Access Compliance Report Public Rights-of-Way (Curb Ramps)

Main Street: SENDERO WAY		Cross Street: NACIENTE ST		Location:	NE
ADA ID: RPRK211117124815	Ramp Type: Type 1 - Perpendicular	Initial Pass/Fail: Fail	Overall Compliance: No	Severity Score:	45

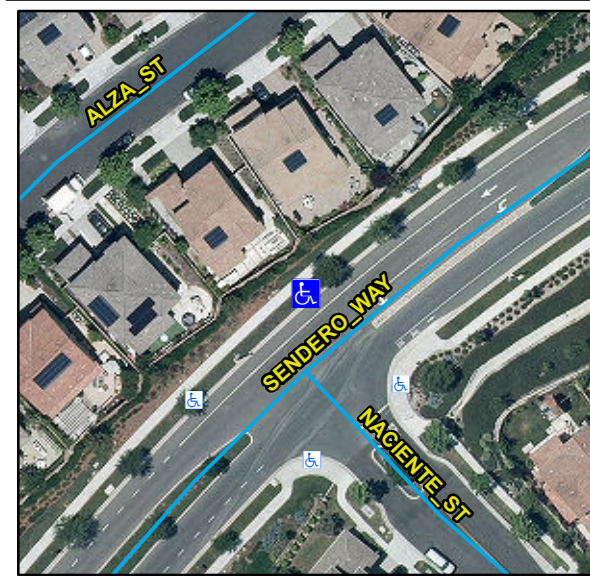
Compliance	Description	Data	Compliance	Description	Data
N/A	Ramp Length (in)	90	N/A	Flare Type LT	
Yes	Ramp Width (in)	60			N/A
No	Ramp Run Slope (%)	9.2	N/A	Flare Slope LT (%)	N/A
No	Ramp Cross Slope (%)	8.9	N/A	Flare Traversable LT	N/A
N/A	Landing Present	N/A	N/A	Flare Type RT	
N/A	Landing Length (in)	N/A			N/A
N/A	Landing Width (in)	N/A	N/A	Flare Slope RT (%)	N/A
N/A	Landing Run Slope (%)	N/A	N/A	Flare Traversable RT	N/A
N/A	Landing Cross Slope (%)	N/A	N/A	DWS Provided	N/A
N/A	Landing Movement Obstructed?	N/A	N/A	DWS Contrast	N/A
	Landing Movement Type	N/A	N/A	DWS Length (in)	N/A
N/A	Landing Shared	N/A	N/A	DWS Full Width	N/A
N/A	Clear Space	N/A	N/A	DWS Offset Left (in)	N/A
N/A	Clear Space To Crosswalk (in)	N/A	N/A	DWS Offset Right (in)	N/A
N/A	Marked Crosswalk 1	No	N/A	Marked Crosswalk 2	N/A
	Crossing 1 Direction	S		Crossing 2 Direction	N/A
	Marked Crosswalk 1 Width (in)	N/A		Marked Crosswalk 2 Width (in)	N/A

N/A	Ramp Inside Crosswalk 1	N/A	Yes	Ramp Inside Crosswalk 2	N/A
	Crossing 1 Slope (%)	9		Crossing 2 Slope (%)	N/A
	Crossing 1 Cross Slope (%)	2.1		Crossing 2 Cross Slope (%)	N/A
N/A	Gutter Ponding	N/A	N/A	Curb Slope	4.2
Yes	Gutter Lip Height (in)	0		Road Run Slope (%)	N/A
N/A	Gutter Run Slope (%)	N/A		Road Cross Slope (%)	N/A
N/A	Gutter Cross Slope (%)	N/A			
Yes	Overall Surface Condition: Acceptable		Yes	Perp Joint Present	Yes
	Cross Gutter Present?	No		Spandrel Present?	No
	Replace Cross Gutter?	N/A		Replace Spandrel?	N/A

Remove & Replace Entire Ramp.
